UNITED STATES PATENT AND TRADEMARK OFFICE

Office Action Summary

10/563,915

DETAILED ACTION

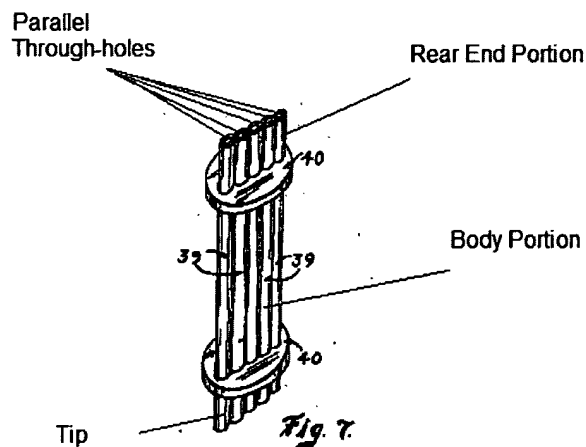
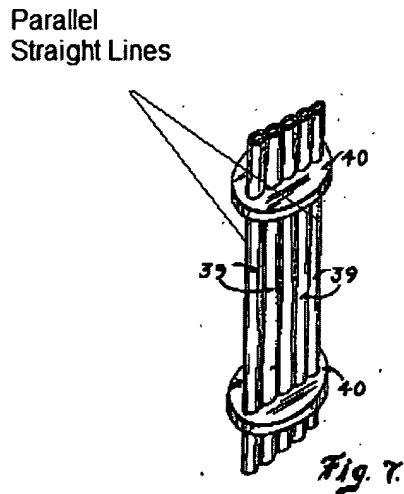
Hipps et al. disclose a device for ligament reconstruction comprising: a tip (top Fig. 7, below) and body portion (top Fig. 7 below) having two parallel through-holes (top Fig. 7 below) (column 3, lines 22-24) formed therein in juxtaposition; and a rear end portion (top Fig. 7 below) having two through-holes (top Fig. 7 below) formed therein in juxtaposition coaxially with the two through-holes of the tip and body portion, wherein the tip and body portion has a uniform and generally elliptical or rectangular cross section (top Fig. 7 below) elongated in a direction in which the through-holes thereof are juxtaposed, so that the tip and body portion is driven into an articular bone to form a flat tunnel in the bone by hitting the rear end portion. The elliptical cross section is of a generally oval shape or a racetrack-like elliptical shape (top Fig. 7, below). The

racetrack-like elliptical shape is defined by a pair of parallel straight lines (bottom Fig. 7, below) and a pair of semicircles connecting opposite ends of the straight lines. The semicircles are the portions of the round tubes (Fig. 7, ref. 39) that are connecting the parallel lines.
